Gables Station

COMPREHENSIVE PLAN MAP AMENDMENT
ZONING MAP AMENDMENT
ZONING CODE TEXT AMENDMENT
PLANNED AREA DEVELOPMENT
MIXED USE SITE PLAN

215 AND 251 S. DIXIE HIGHWAY
CITY COMMISSION 2ND READING
JULY 26, 2016

#1: BUILDING HEIGHT

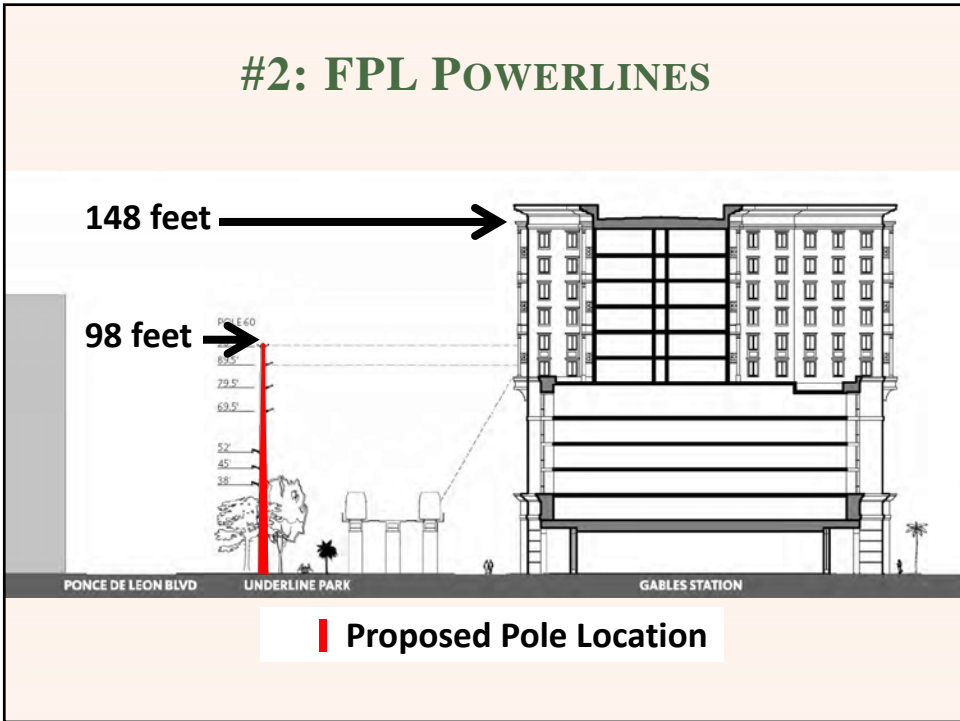
1. Reduce building height while maintaining the same percentage of open space.
2. Show FPL powerline locations in drawings of the Underline.
3. Finalize the trolley contribution proposal.
4. Confirm the timing of the Underline improvements.
5. Update the Traffic Impact Study.
6. Provide the Art in Public Places concept.
7. Update site plan to include more landscaping at the ground level.

Due to the specific site characteristics of this Mixed-Use redevelopment site adjacent to Metrorail and its associated noise and visual impacts, **Staff recommends approval of the project at the height proposed by the Applicant: 160 feet for Building A and 148 feet for Buildings B and C.** The proposed height is less than the maximum height allowed in the City (190'6").
